TECHNICAL TIPS #27  
OCTOBER 1991

\* SPORTSTER MODELS \*

1992 CYLINDER HEADS & HEAD BOLTS

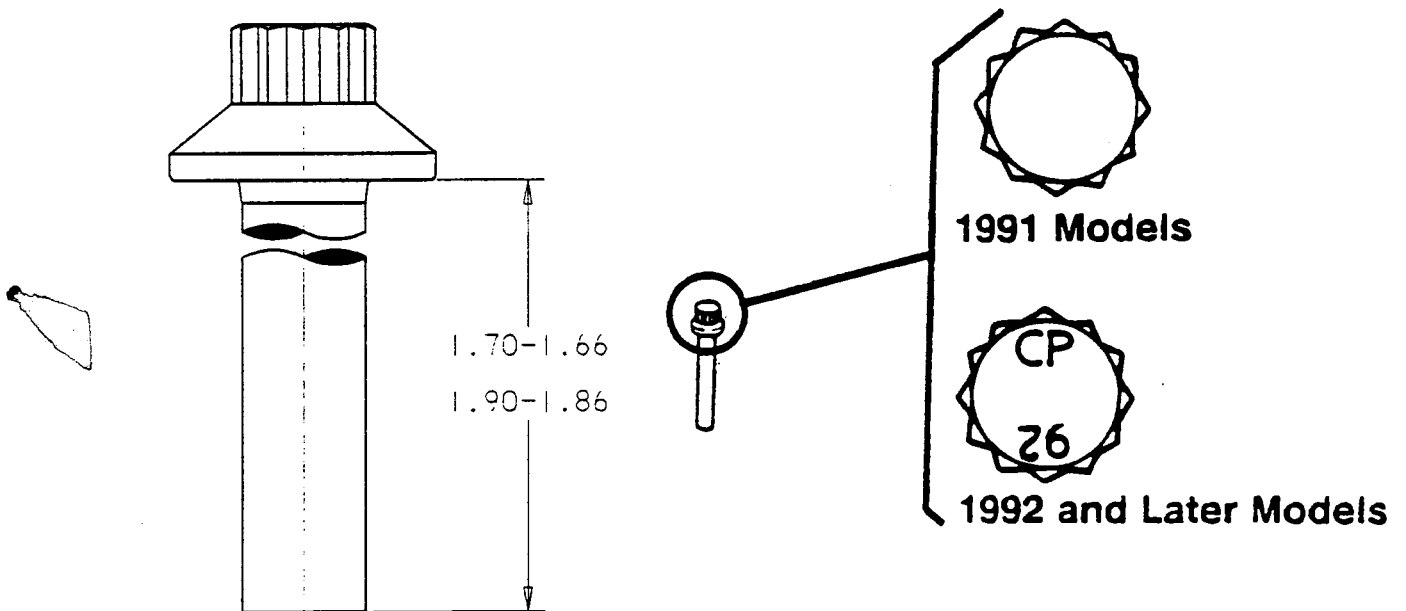
On 1992 cylinder heads, the head bolt counterbore, on the spark plug side, was reduced in depth. This change was made for ease of manufacturing. To maintain sufficient thread engagement, the head bolt length was increased. The new head bolts are identified with the number "92" on the bolt head. (1991-92 XL Service Manual-page 3-14) These new head bolts cannot be used on any vehicles other than 1992 Sportsters.

A small quantity of early 1992 Sportsters were built using the longer head bolts that DO NOT have the "92" identification on them. The only way to tell these from 1986-1991 bolts is by measuring the length. ( see illustration). Remember, this affects only early 1992 XL's.

The new cylinder heads are sold as a kit, with the bolts, to retrofit to 1991 vehicles.

## 1992 SPORTSTER PRODUCT CHANGES

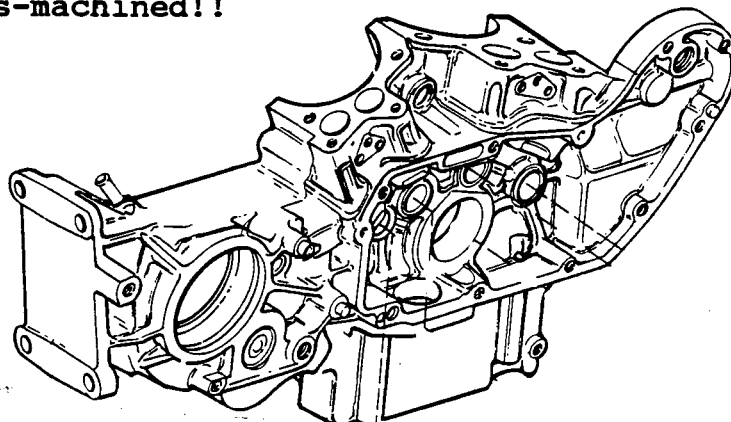
The oiling system by-pass has been eliminated from 1992 Sportster crankcases. This change was made to "borrow" oil for the cam gear oiler in the gearcase compartment. All 1991 replacement crankcases will also have these two features. The crankcases are not mis-machined!!

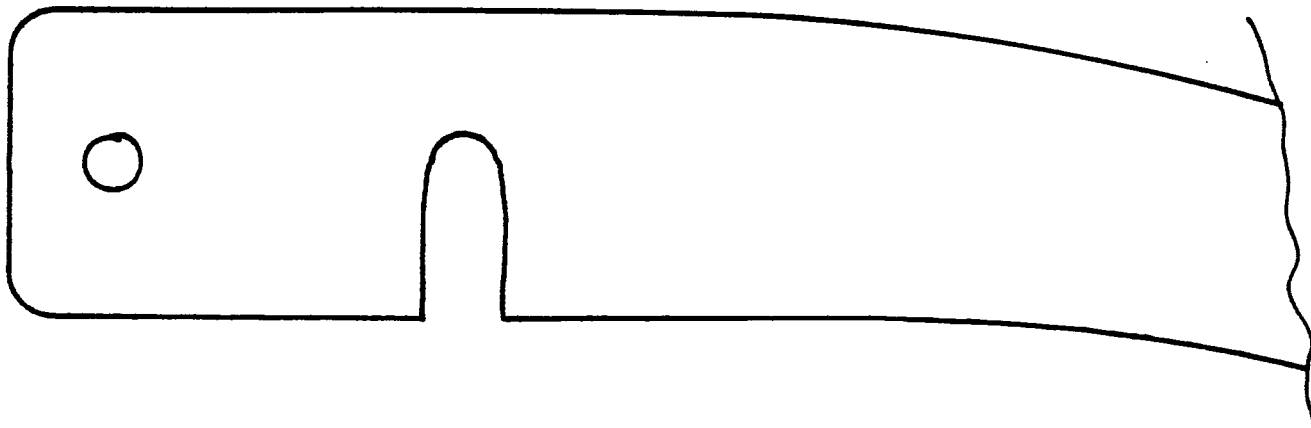
LET'S PLAY THE SLOTS!! , not VEGAS - FENDER STRUTS!!!  
Fender struts were added in 1990 to provide rigidity to the rear fender.  
In late September, the struts were slotted to make servicing and accessory installation easier.
